Access Compliance Report

Public Rights-of-Way

(Curb Ramps)

Intersection ID: 3637	Main Street: SHENINGTON_PL	Cross Street: TREYBURN_DR	Location: NE
ADA ID: 89363C42877A	Ramp Type: BlendTrans2	Initial Pass/Fail: Fail	Overall Compliance: No
Codes/Mitigation Info/Possible Solution		Field Measurements/Component Compliance	
Severity Score: 8.75

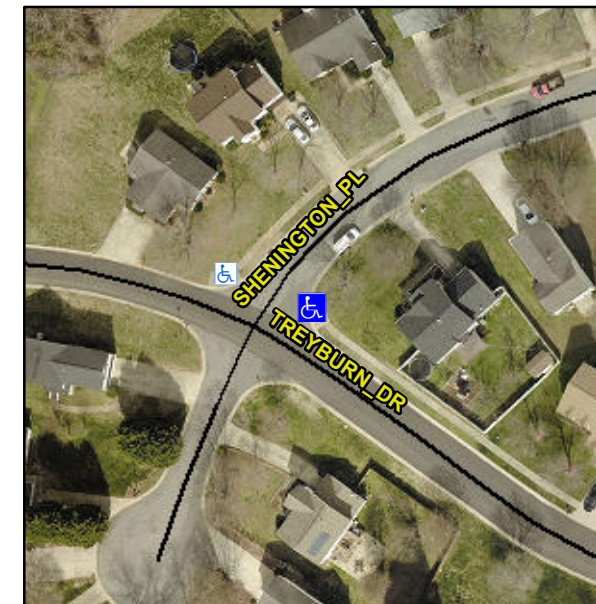
NO LT SW

Not Found, R304.5.1

Remove & Replace Curb Ramp With Two New Directional Ramps or Equivalent.
